Traffic and Transportation

In accordance with the MEPA Scope, this chapter directly responds to agency and public review comments within MEPA jurisdiction. Copies of the Secretary's Certificate on the Draft Environmental Impact Report (DEIR) and each comment letter received during the public review period of the DEIR are included in this chapter. This chapter provides responses to those letters.

Table 6-2 Response to Comments

1 PAVILION FLOOR PLAN
SCALE: 1/4" = 1'-0"

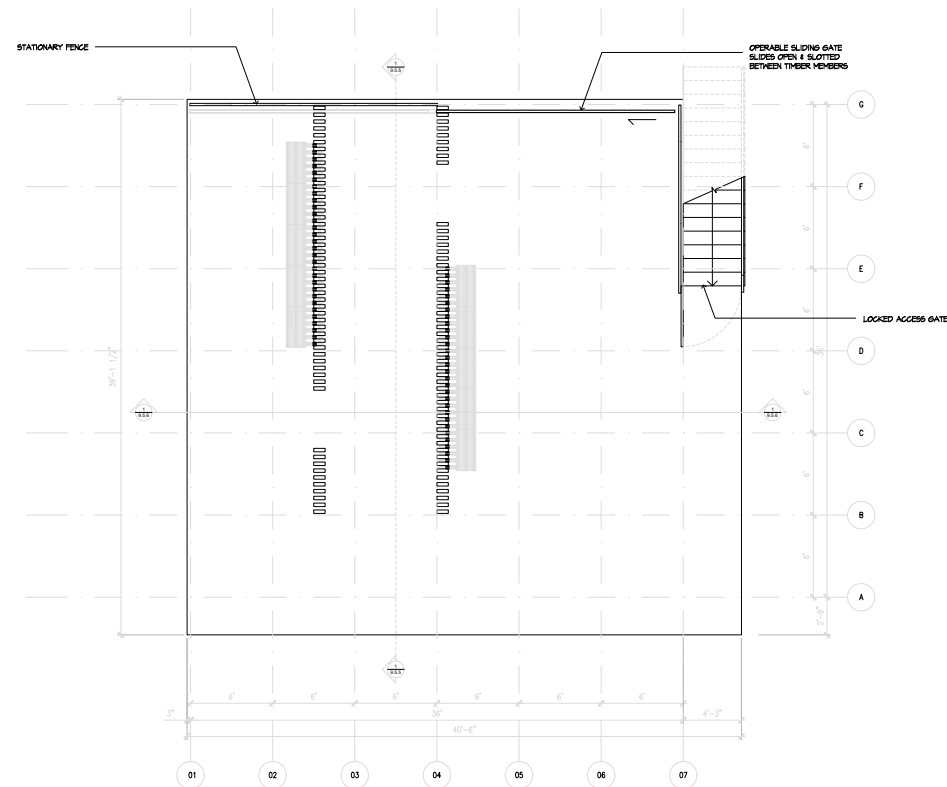
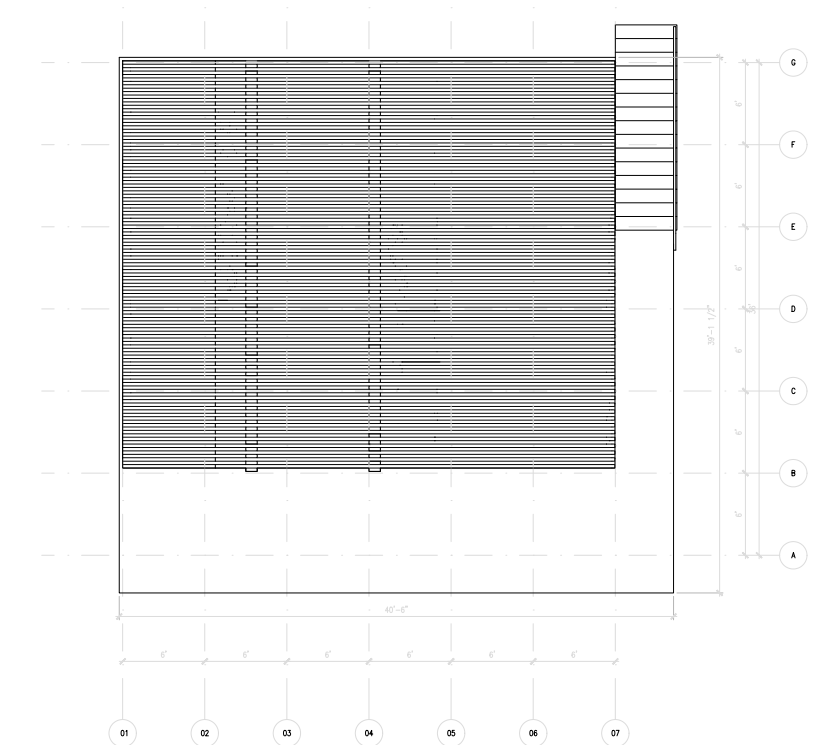
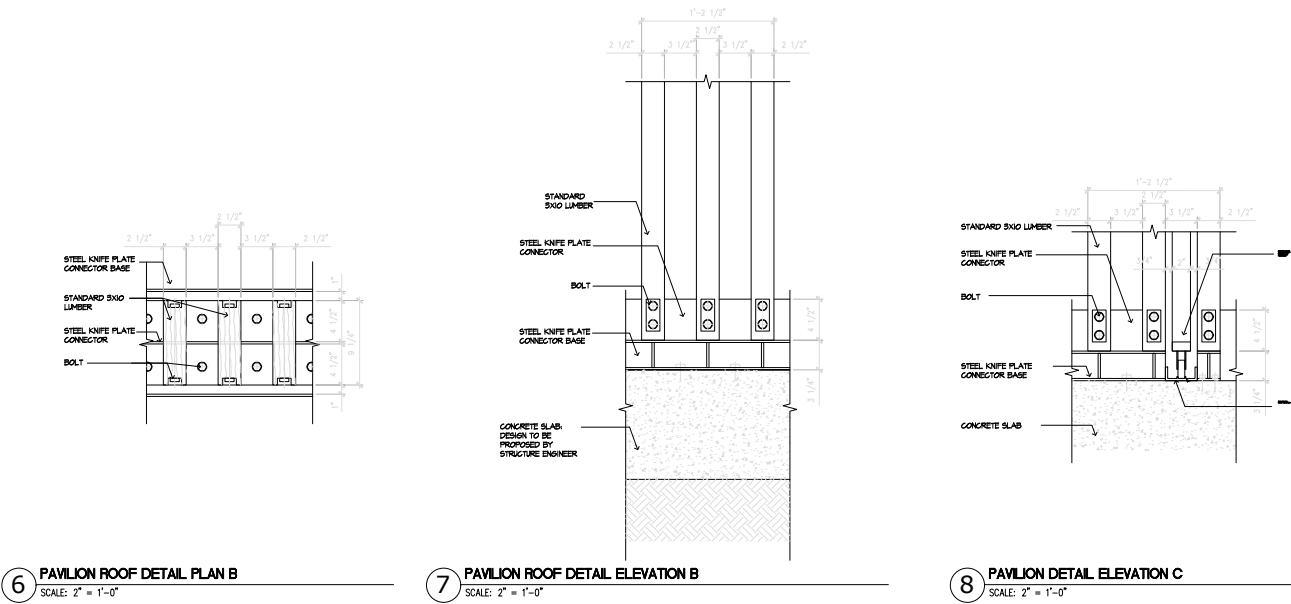
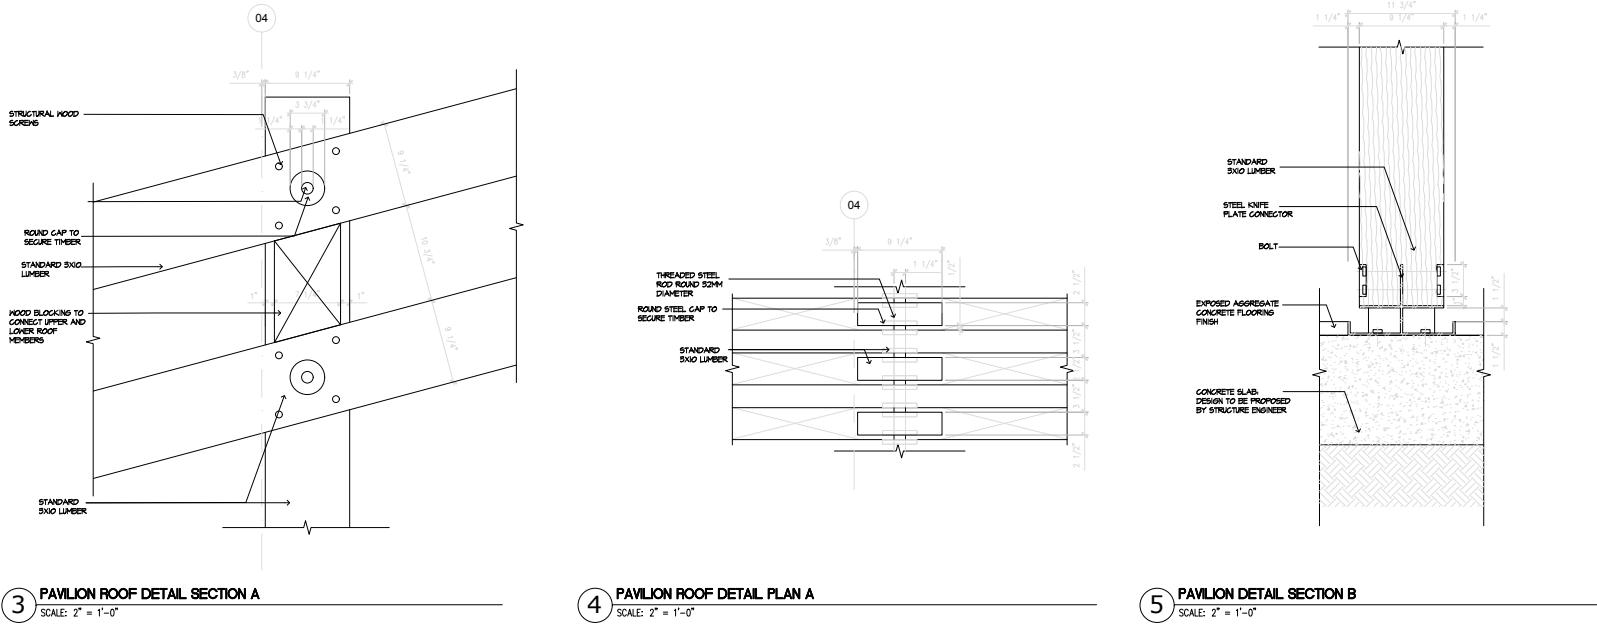
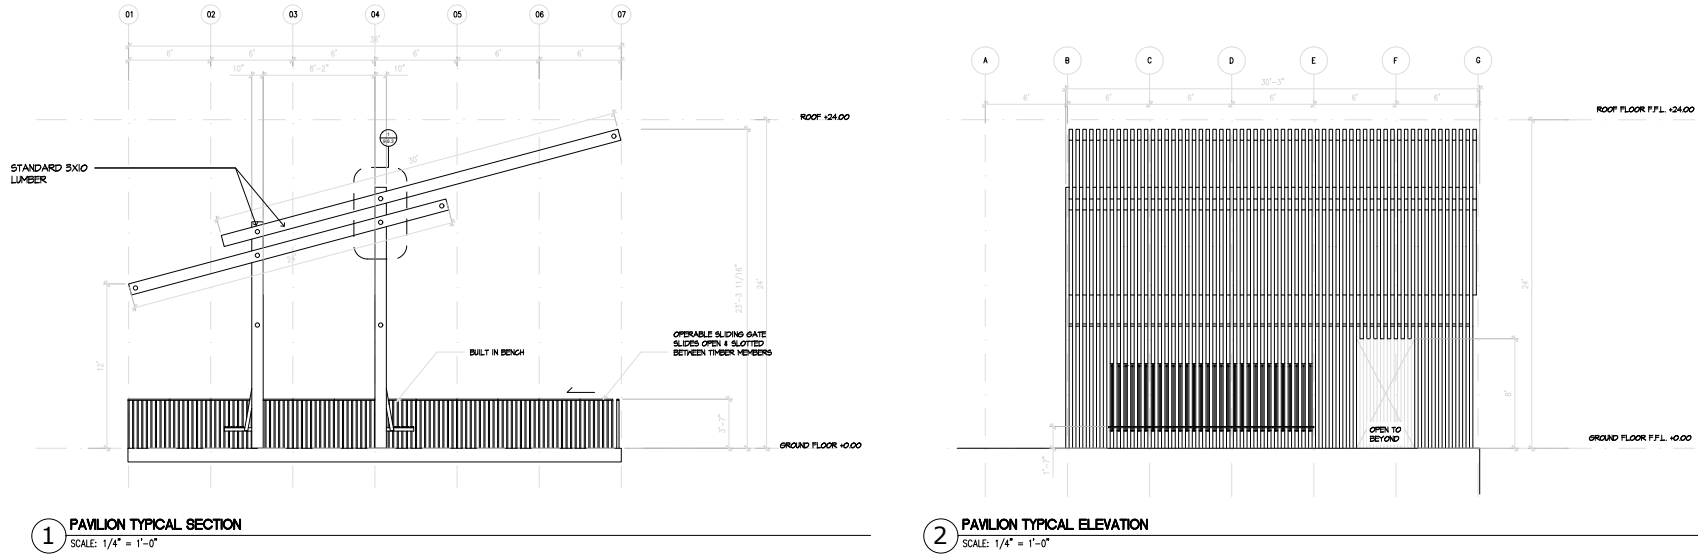
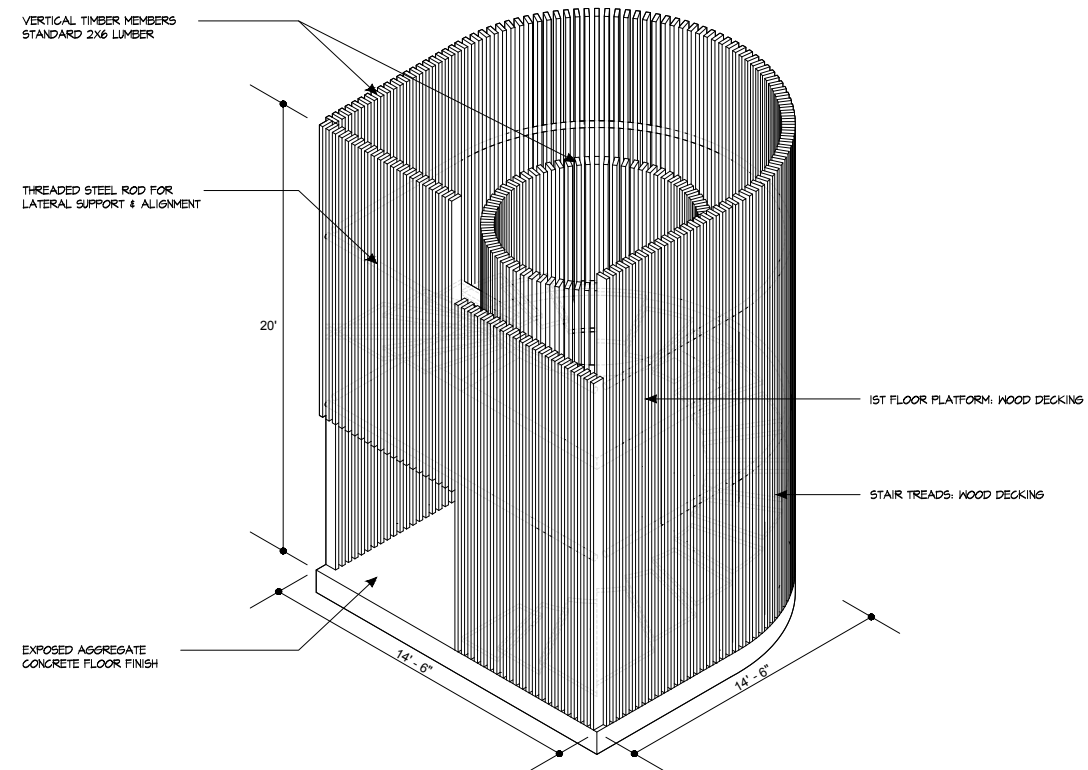
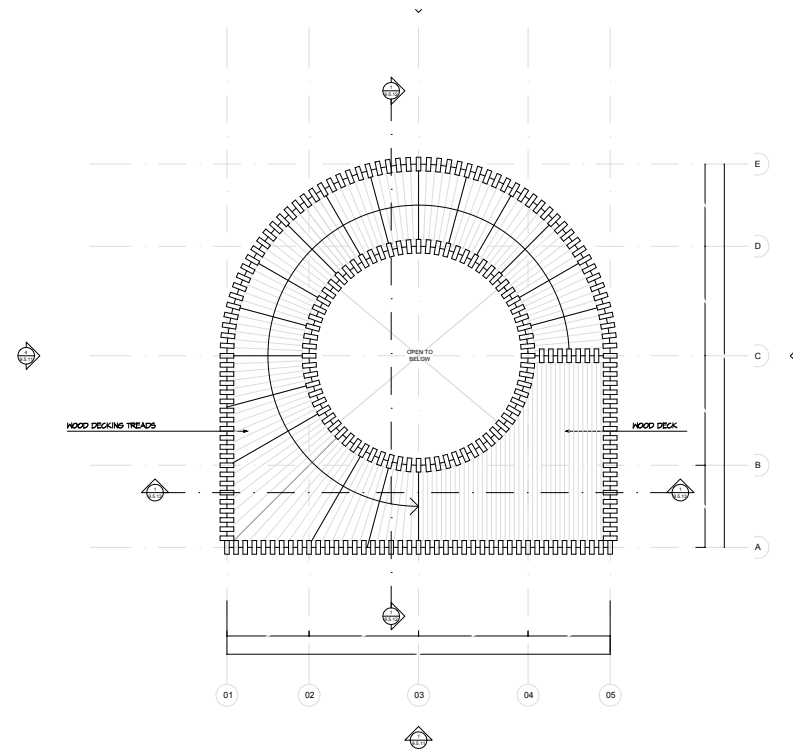
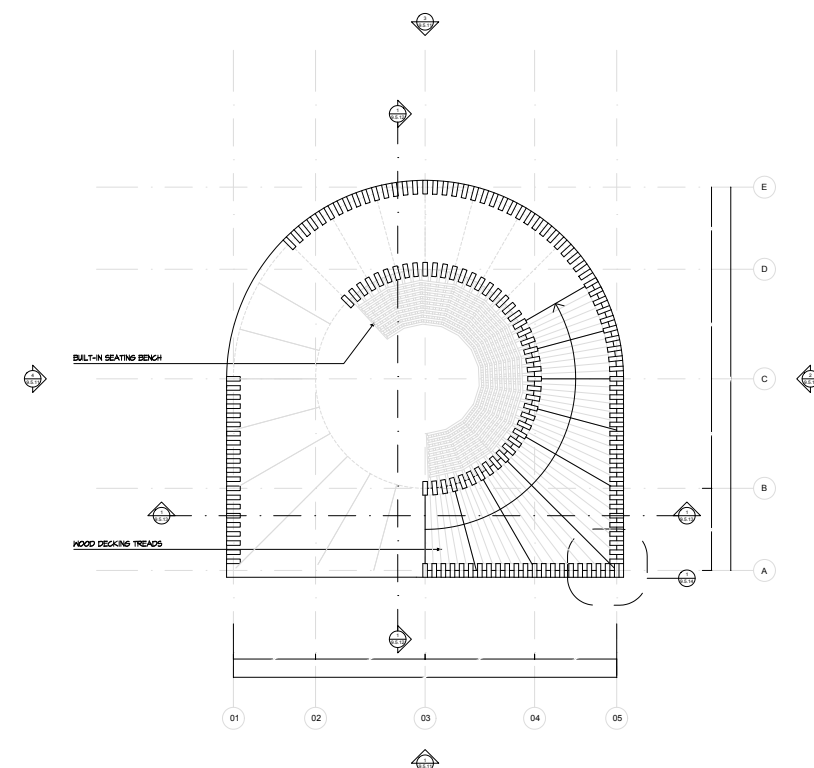
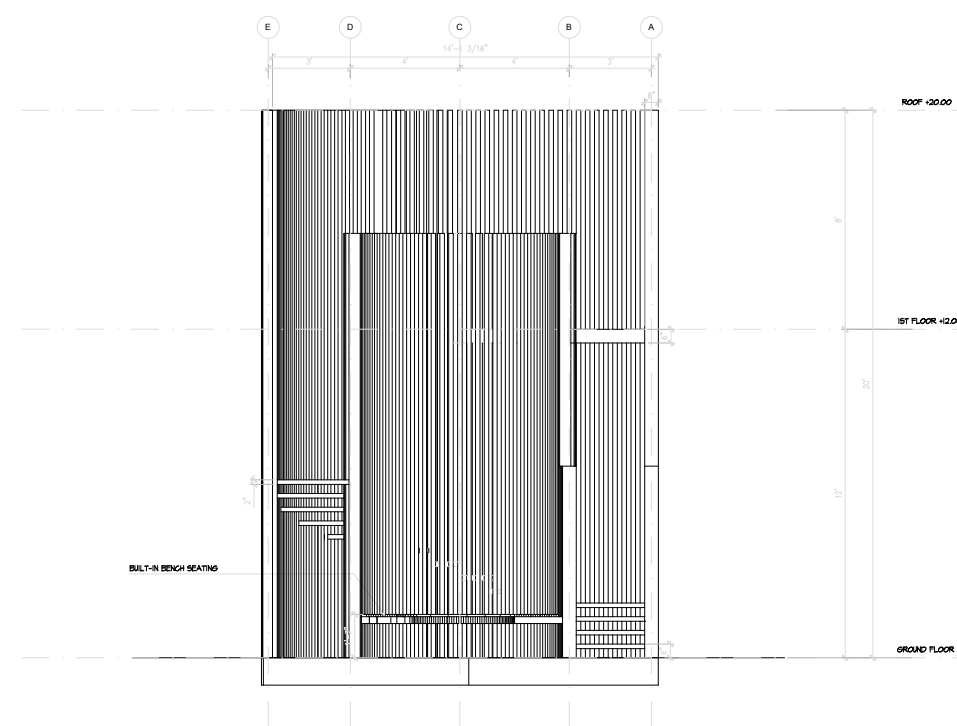
1.35	The FEIR should provide a plan clearly showing all project components within the Riverfront Area, quantify potential impacts to all wetland resource areas and floodplain and describe mitigation measures.	Figures 4.1 - 4.4h provide information on the plantings proposed for the Project and work within the existing daylighted section of South Meadow Brook. No work is proposed within Land Under Waterbodies and Waterways. Refer to Section 4.1 of Chapter 4, <i>Wetlands</i> for more details.

Comment #	Commenter	Comment	Response
5.04 CRWA	<p>Finally, given that the project includes work proposed in the 200 ft. Riverfront Area (RA) of the daylighted section of the South Meadow Brook, the FEIR should contain more details regarding the nature of the work. While the Proponent has committed to improving the RA by reducing the area of pavement and by planting a diverse selection of native trees, shrubs, and other plants, the FEIR should include a much more comprehensive stream restoration plan and supporting details.</p>		<p>Section 4.1 of Chapter 4, <i>Wetlands</i> includes a description the restoration of elements of the South Meadow Brook Riverfront Area. Figures 4.1 - 4.4h provide information on the plantings proposed for the Project and work within the existing daylighted section of South Meadow Brook.</p>
